29 June 2026

Major Projects – Kangaroo Bay Hotel

1. Adherence to Austroads Guide to Road Design Part 6A Paths for Cycling and Walking

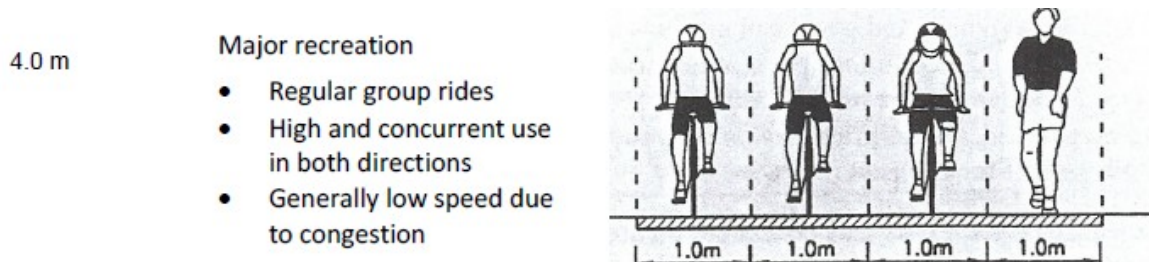
The proposed 3.0m wide shared path around the foreshore is inadequate for the amount and type of use. Due to the side friction from people entering and exiting the outdoor dining area and blocks used for seating, the clear width of the path should be 4.0m. Seating should be arranged so that legs are not intruding onto the path.

Austroads 2021 Part 6A – Page 83

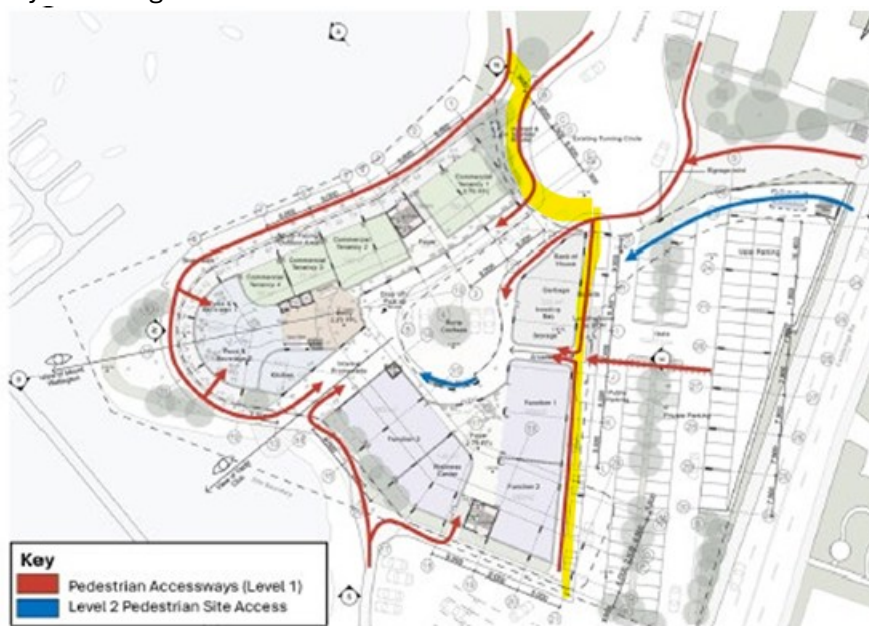
Austroads recommends a preferred clearance of 1.0m from the edge of the path to a fixed object and a minimum of 0.3m if space is insufficient.
